# DART SERVICE INSTRUCTION

## TO AMEND INSTALLATION INSTRUCTIONS IIN-D350-689 REV. B AND INSTRUCTIONS FOR CONTINUED AIRWORTHINESS ICA-D350-689 REV. 1

REF. TCCA STC: SH02-33  
REF. FAA STC: SR01620NY  
REF. EASA STC: EASA.IM.R.S.01453  
REF. TCA STC: 2005S03-09

### 1.0 PURPOSE

**FIGURE 1: UPDATES TO CROSS SECTIONS F-F AND M-M**  
 With reference to Figures 5 and 7 of IIN-D350-689  
 (Figures 25-5 and 25-7 of ICA-D350-689)

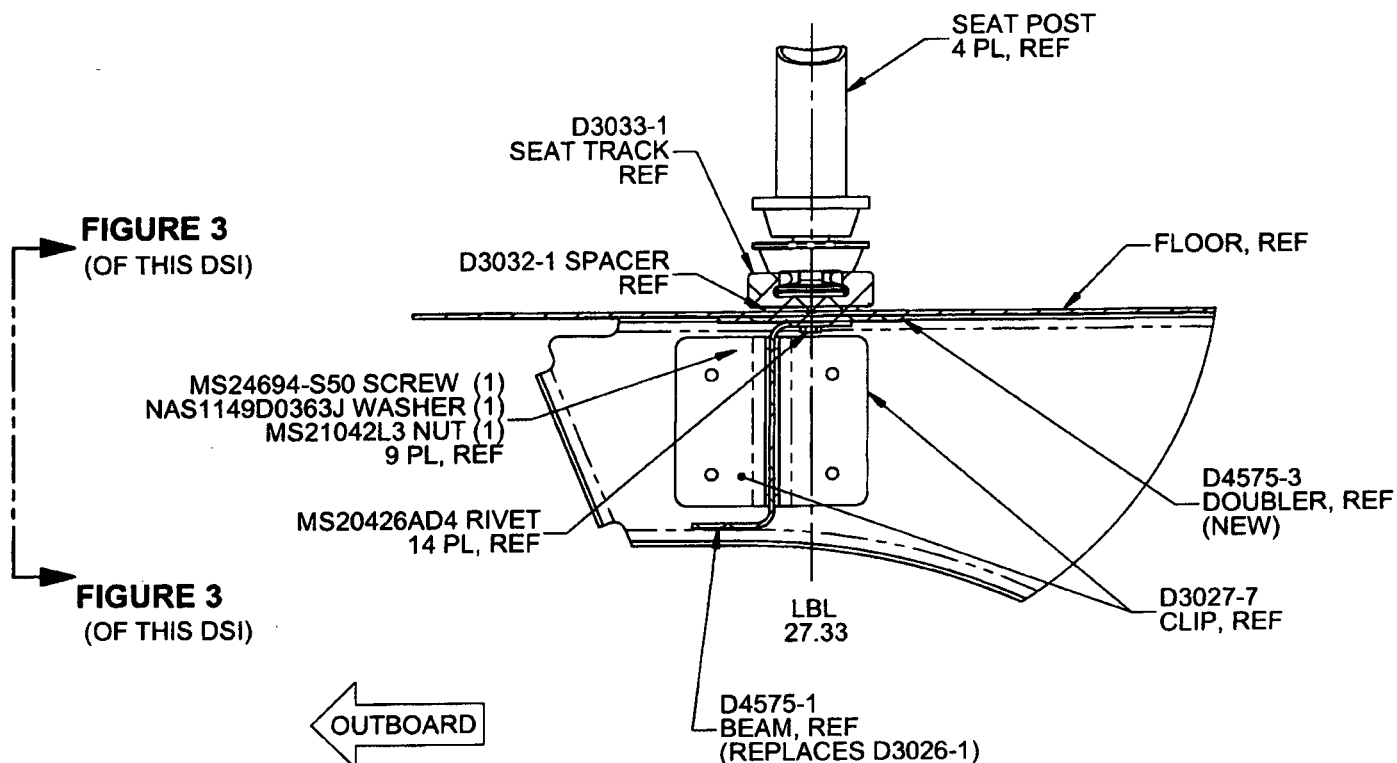
If there is an existing stringer at LBL 27.33, it will need to be removed from that location. Locate D4575-1 Beam, D4575-3 Doubler, and D3032-1 Spacer as shown in Figure 1 of this Service Instruction. Transfer drill existing holes from the aircraft floor to the D4575-1 Beam, D4575-3 Doubler, and D3032-1 Spacer. Ensure 1.0" to 1.5" rivet pitch and add additional holes if required. If there is no existing stringer, locate D4575-1 Beam, D4575-3 Doubler, and D3032-1 Spacer as shown in Figure 1 of this Service Instruction, and drill Ø0.128" holes on a 1.0" to 1.5" pitch.

If there is an existing stringer at LBL 27.33, it will need to be removed from that location. Locate D3026-1 Channel as shown in Figure 4 and transfer existing holes from the aircraft floor to the D3026-1 Channel & D3032-1 Spacer. Ensure 1.0" to 1.5" rivet pitch and add additional holes if required. If there is no existing stringer, locate D3026-1 Channel & D3032-1 Spacer as shown in Figure 4 and drill Ø0.128" holes on a 1.0" to 1.5" pitch.

If there is an existing stringer at LBL 27.33, it will need to be removed from that location. Locate D4575-1 Beam and D4575-3 Doubler as shown in Figure 2 of this Service Instruction. Transfer drill existing holes from the aircraft floor to the D4575-1 Beam and D4575-3 Doubler. Ensure 1.0" to 1.5" rivet pitch and add additional holes if required. If there is no existing stringer, locate D4575-1 Beam and D4575-3 Doubler as shown in Figure 1 of this Service Instruction and drill Ø0.128" holes on a 1.0" to 1.5" pitch.

If there is an existing stringer at LBL 27.33, it will need to be removed from that location. Locate D3026-1 Channel as shown in Figure 4 and transfer existing holes from the aircraft floor to the D3026-1 Channel. Ensure 1.0" to 1.5" rivet pitch and add additional holes if required. If there is no existing stringer, locate D3026-1 Channel as shown in Figure 4 and drill Ø0.128" holes on a 1.0" to 1.5" pitch.

**FIGURE 3: RELIEFS ON D4575-1/-3**  
(ONLY D4575-1/-3 SHOWN FOR CLARITY)  
VIEW LOOKING INBOARD

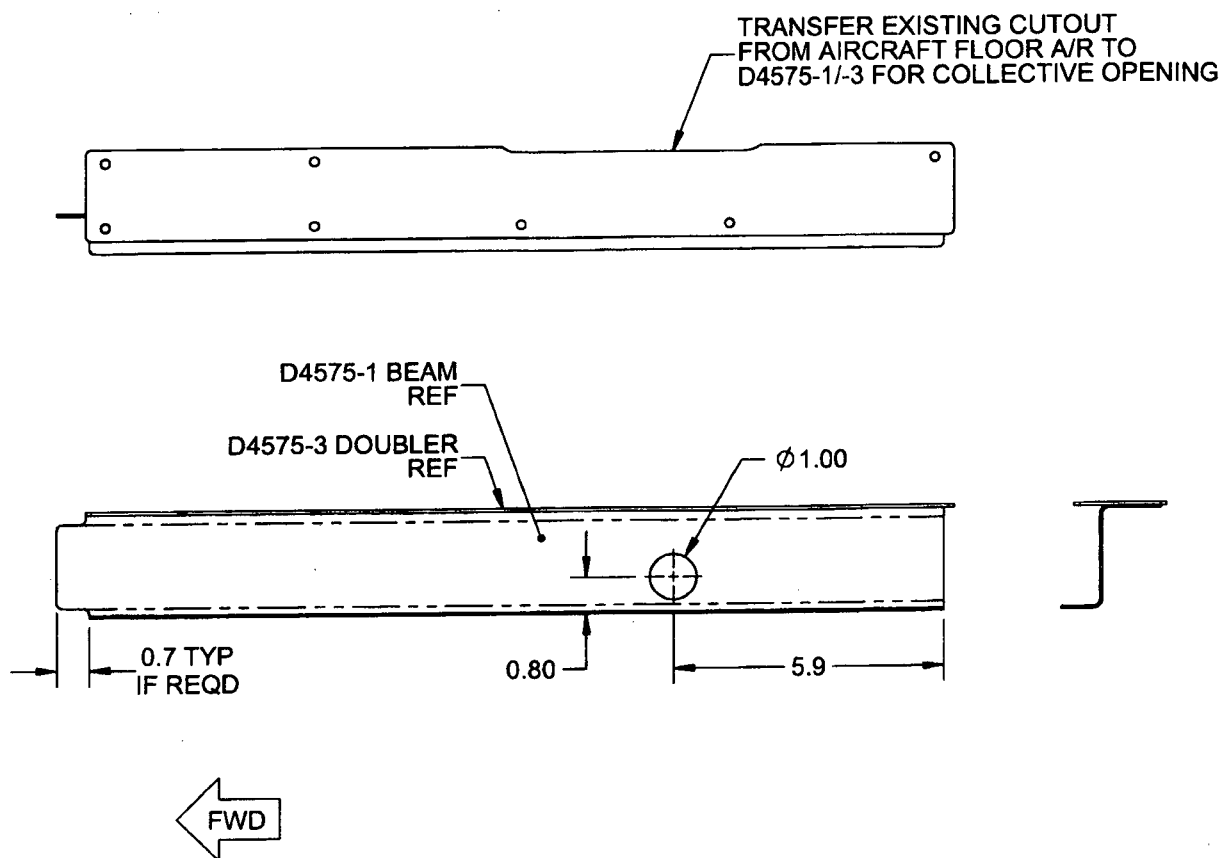
**Note:** Drill a Ø1.00" (Ø25.4 mm) hole in the D4575-1 Beam to clear extension tube of collective and cutout as required for clearance of collective opening and fwd bulkhead as shown in Figure 3 of this Service Instruction.

**Note:** Drill a Ø1.00" (Ø25.4 mm) hole in the D4575-1 Beam to clear extension tube of collective and cutout as required for clearance of collective opening and fwd bulkhead as shown in Figure 3 of this Service Instruction.
